and Management Parameters for 10 Mb/s Operation and Associated Power Delivery over a Single Balance

[6] Insert a new Figure 145-6 shown below (view using a non-proportional font such as courier), renumbering the following figures as required.

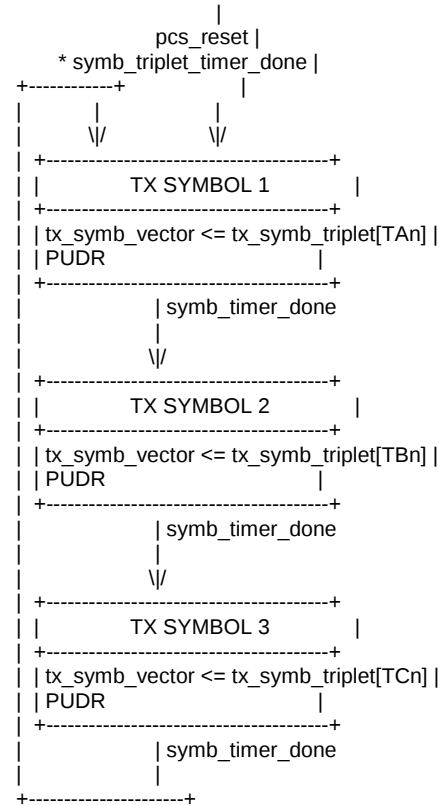
Is it correct that 'The PCS Transmit function shall conform to the PCS Transmit state diagram in Figure 146-5 ...' and that 'In each symbol period, PCS Transmit generates a symbol An provided to the PMA ...'? The PCS Transmit state diagram in Figure 146-5 changes state based on STD being true, with STD being an alias for symb_triplet_timer_done, and the output of the PCS Transmit state diagram is tx_symb_triplet which is defined in subclause 146.3.3.1.1 'Variables' as 'A triplet of ternary symbols generated by the PCS Transmit function after 4B3T encoding.'

I think the problem is that there is another function within the PCS Transmit function that is missing from the PCS Transmit state diagram in Figure 146-5, the 'multiplexor' shown in Figure 146-6 'PCS transmit symbol generation'. This 'multiplexor' function operates at the symbol clock rate and serialises the tx_symb_triplet code-groups output by the PCS Transmit state diagram into individual symbols.

This may also explain when subclause 146.3.3.1.3 'Timers' defines the symb_timer that is not used in the PCS Transmit state diagram in Figure 146-5.

[4] Add a new subclause 146.3.3.2.2 titled 'Timers'. Move the symb_timer definition from subclause 146.3.3.1.3 Timers to this new subclause.

[5] Add a new subclause 146.3.3.2.4 'Abbreviations' that reads:

[7] Add text to subclause 146.3.3 'PCS Transmit' that reads 'The PCS Transmit function shall conform to the PCS Transmit state diagram in in Figure 146-5 and the PCS Transmit multiplexor state diagram in 146-6, and their associated state variables, functions, timers, and messages.'
